Owner Change Order (OCO)

Project Name: Brookline - Driscoll School
Gilbane Job No.: J08864.000

OCO: OCO-0012

Scope Of Changes: Owner Change Order 12 Misc Changes

Project
 TOWN OF BROOKLINE
 DRISCOLL SCHOOL
 Sketch Title
 RFI-249 MURAL IN GYM

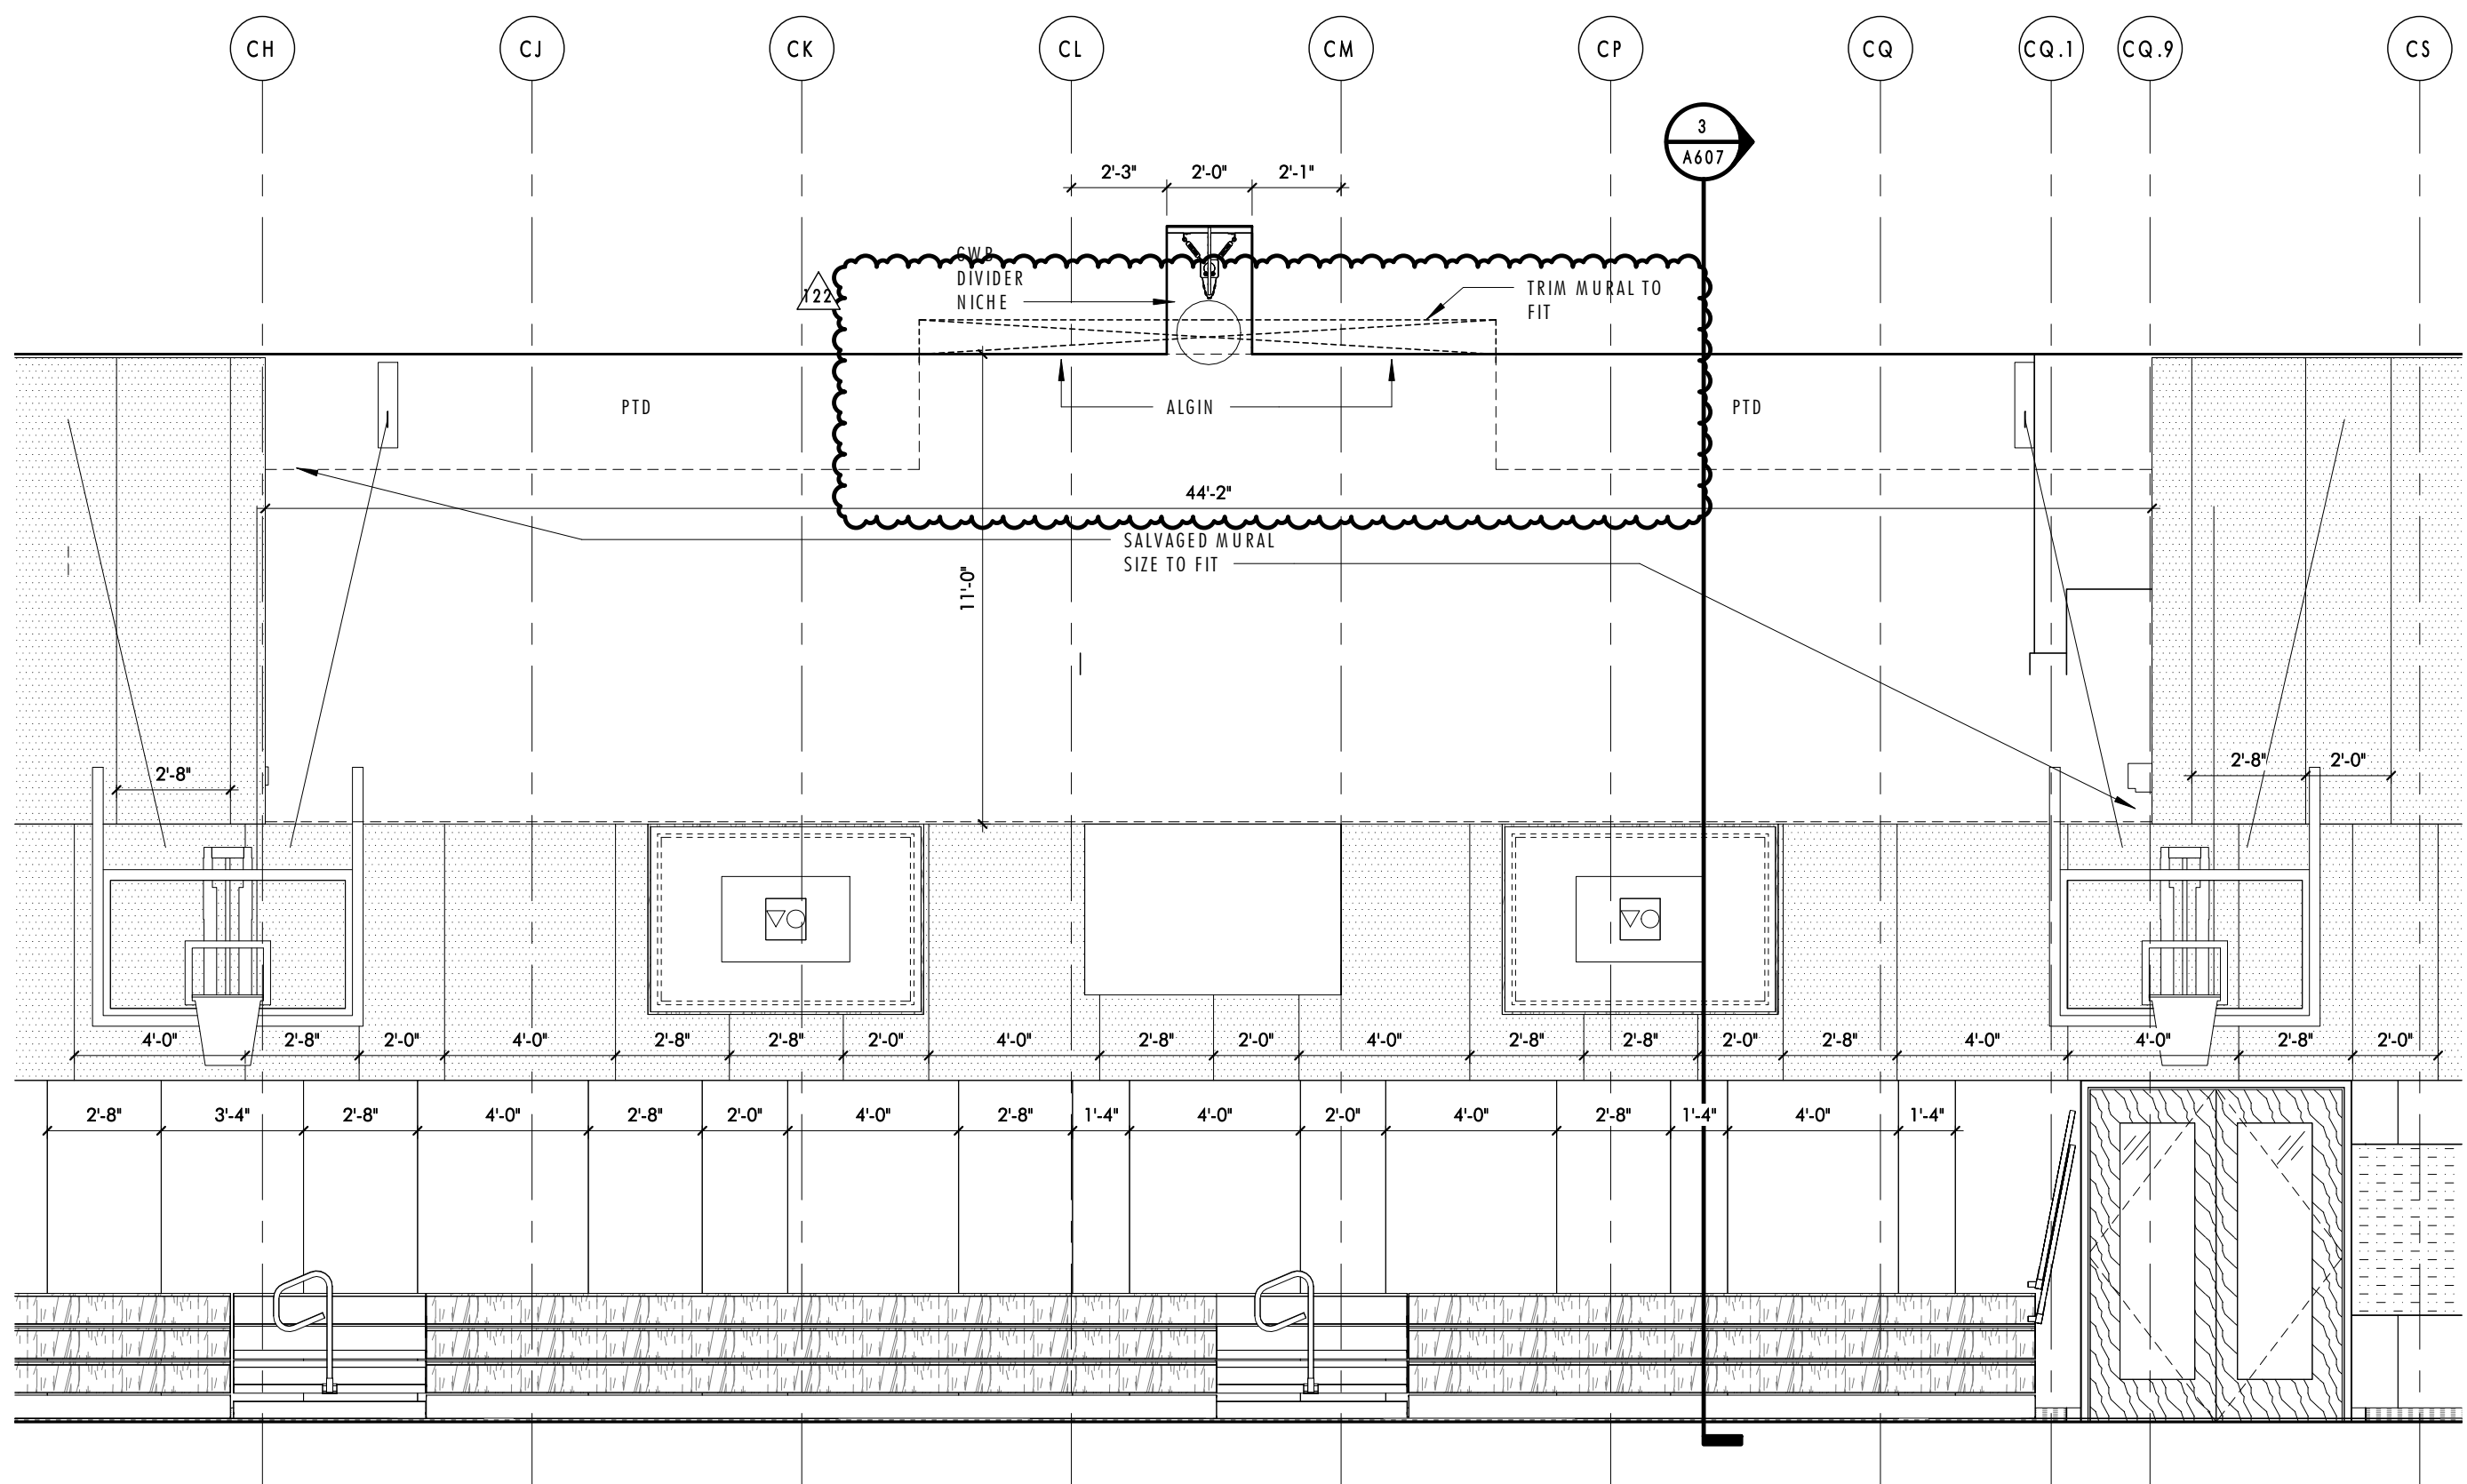
Enlarged Elevation Plan 3/A435 indicates "salvaged mural sized to fit" on the South wall of the gym above the acoustical wall panels. The mural space shown on the drawing is 44'-0"W x 10-9"H. Based on field measuring the actual mural it is: 44'-2"W X 11'-9" +/- H. The mural will not fit in the spaced allotted. The (2) display cases/ monitor enclosures, (1) scoreboard, (17) acoustical wall panels and (2) basketball backboard supports will be in conflict with the mural. (The gym divider wall may also be impacted with the mural projection.) Please review and provide revised layout for South wall of the gym.

*NOTE: There is a possibility the top 45" extension of the mural could be omitted. This would affect the look of the artwork- but may be possible. The basketball backboard support conflict would still be a problem.

Trim mural top to fit, opening width revised to accept dimension provided. Refer to attached ASK-093.

Sketch Title
ASI 012 - ELEVATOR STRUCTURE
MODIFICATIONS - CLEAR OVERHEAD

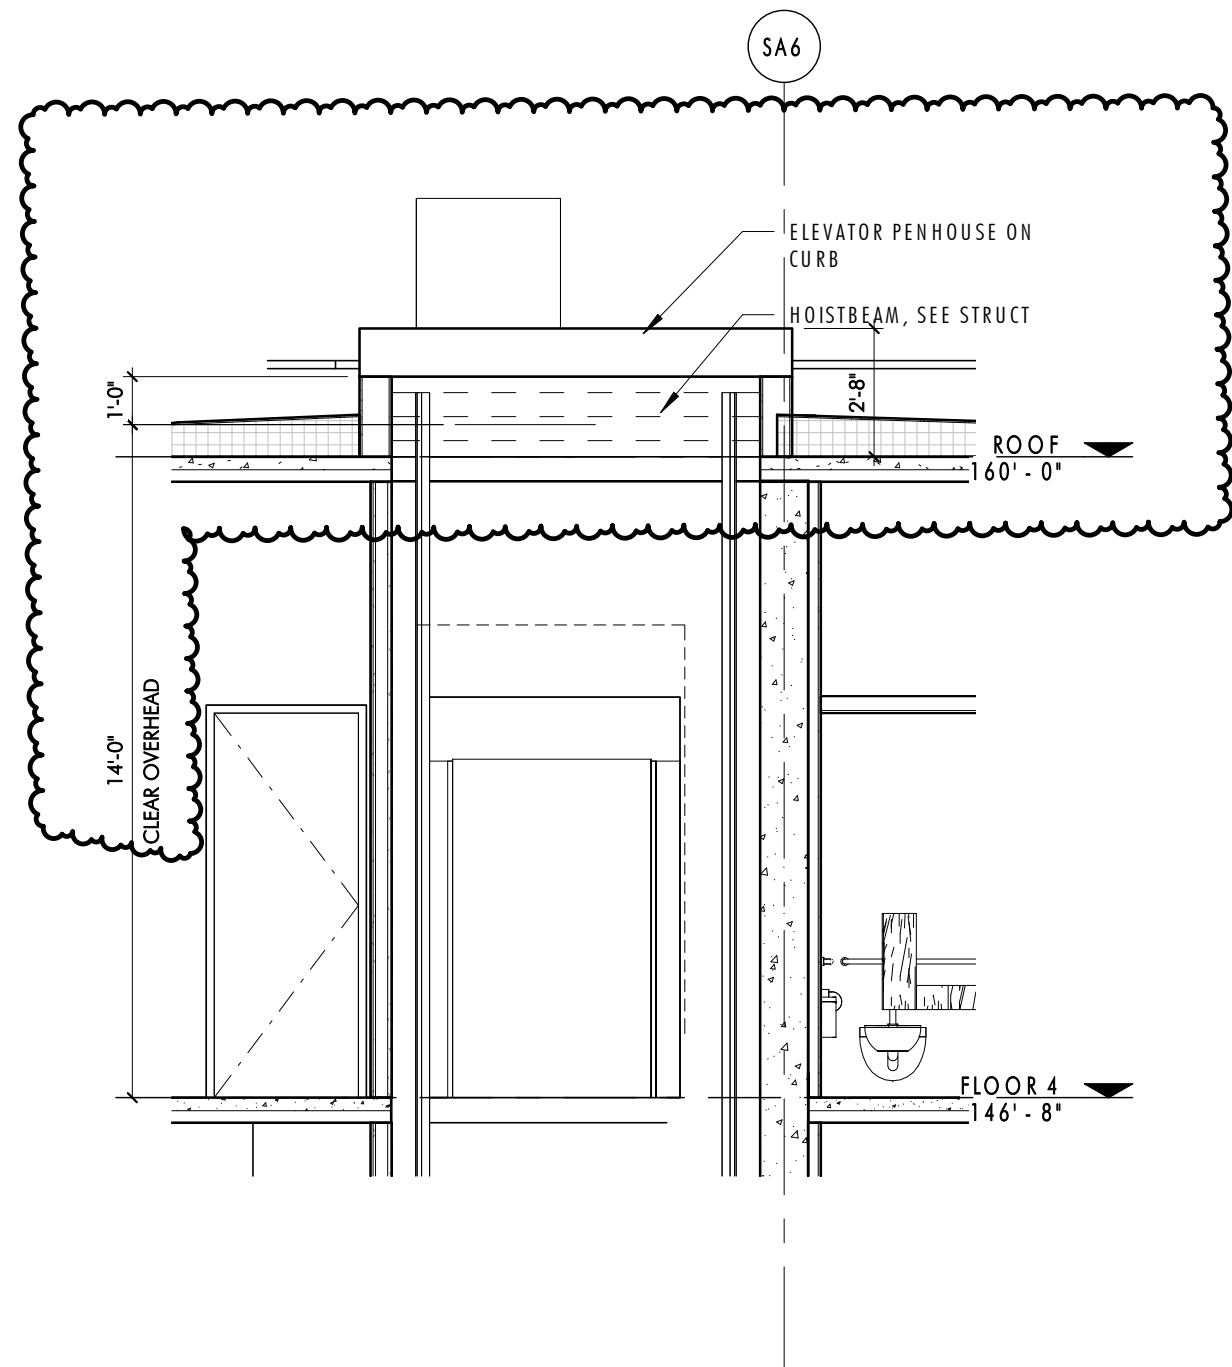
- 1) Modifications noted below from LeMessurier for clarifications regarding elevator coordination and core shear wall information; refer to attached sheets S015, S100A, S104A, S105A, S223, S224.
 - Enlarged elevator opening at Floor 0 (8" to west – to be infilled with drywall, 1'-8" to the east – to be infilled with concrete). Detail added for concrete infill.
 - Enlarged elevator opening at Floor 4 (8" to west, 1'-8" to east – both to be infilled with drywall)
 - Located and finalized size of rail support HSS members on west side of elevator shaft.
 - Located hoist beam.
 - Included sill support information.
 - Set Elevator Override top of steel.
- 2) Elevator clear override dimension at roof revised per coordination with elevator submittal #14 21 43-001; refer to attached sketch A SK 046.
